Access Compliance Report

Public Rights-of-Way

Intersection ID: 6555	Main Street: UNIVERSITY_CITY_BV	Cross Street: SANCTUARY_PL	Location: NE
ADA ID: FEC4D4777366	Ramp Type: Perp	Initial Pass/Fail: Fail	Overall Compliance: No
Codes/Mitigation Info/Possible Solution		Field Measurements/Component Compliance	
Severity Score: 22.5

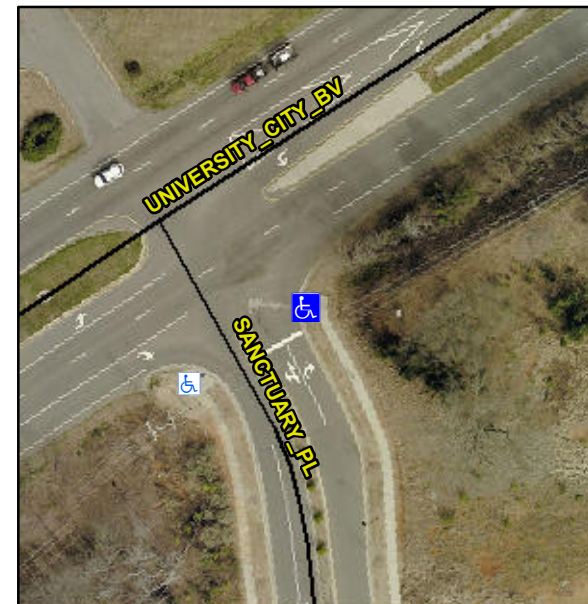
Not Found, R304.5.1, R304.2.2, R304.5.3

Compliance	Description	Data	Compliance	Description	Data
N/A	Ramp Length (in)	96.0	No	Ramp Slope (%)	9.2
No	Ramp Width (in)	43.0	No	Ramp XSlope (%)	2.3
N/A	Flare Type LT	N/A	N/A	Flare Type RT	N/A
N/A	Flare Slope LT (%)	N/A	N/A	Flare Slope RT (%)	N/A
N/A	Flare Traversable LT?	N/A	N/A	Flare Traversable RT?	N/A
N/A	Landing Length (in)	N/A	N/A	DWS Provided?	N/A
N/A	Landing Width (in)	N/A	N/A	DWS Contrast?	N/A
N/A	Landing Slope (%)	N/A	N/A	DWS Length (in)	N/A
N/A	Landing X Slope (%)	N/A	N/A	DWS Full Width?	N/A
N/A	Landing Curb? (Y/N)	N/A	N/A	DWS Offset (in)	N/A
N/A	Shared Landing?	N/A			
N/A	Gutter Ponding?	N/A	N/A	Gutter Slope (%)	N/A
N/A	Gutter Lip Ht (in)	N/A	N/A	Gutter X Slope (%)	N/A
N/A	Painted X Walk1?	No	N/A	Painted X Walk2?	N/A
	X Walk 1 Direction	To W		X Walk 2 Direction	N/A
N/A	X Walk 1 Width (in)	N/A	N/A	X Walk 2 Width (in)	N/A
	X Walk 1 Slope (%)	2.7		X Walk 2 Slope (%)	N/A
	X Walk 1 X Slope (%)	0.5		X Walk 2 X Slope (%)	N/A

Remove & Replace Entire Ramp.
